Application Number: 10/091,502
Filing Date: March 07, 2002
Appellant(s): CHE ET AL.

EXAMINER'S ANSWER

This is in response to the appeal brief filed 03/05/2004.

FIG. 1

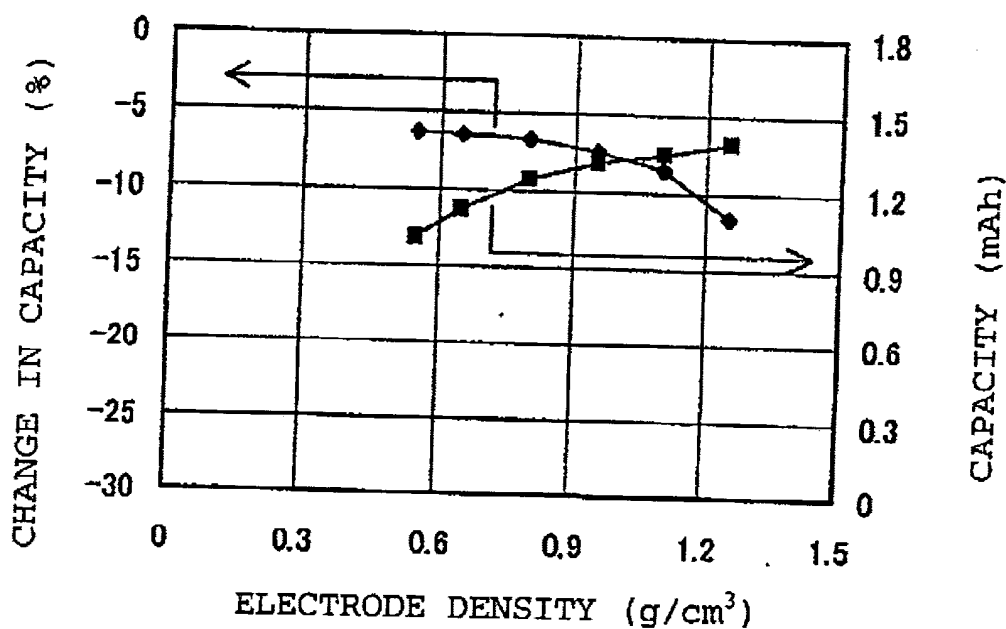
Furthermore, the objective evidence of nonobviousness is not commensurate in scope with the instant claims which the evidence is offered to support. For instance, it is noted that data of Figure 1 showing improved capacity and cycle reduction characteristics does not evidence unexpected results for the entire claimed range of 0.6-1.2 g/cc or 0.7-1.0 g/cc because as

apparent from Figure 1 below, significant initial capacity of more than 1.2 mAh is reached at negative electrode densities greater than about 0.8-0.85 g/cc (not 0.6 g/cc or 0.7 g/cc as instantly claimed) and significant reduction in capacity of more than 7 % (assuming that 7 % is an acceptable reduction) are observed at negative electrode densities as low as about 0.9 – 0.95 g/cc or higher (not 1.0 g/cc or 1.2 g/cc as instantly claimed). For that reason, it is contended that the objective evidence of nonobviousness is not commensurate in scope with the present claims.
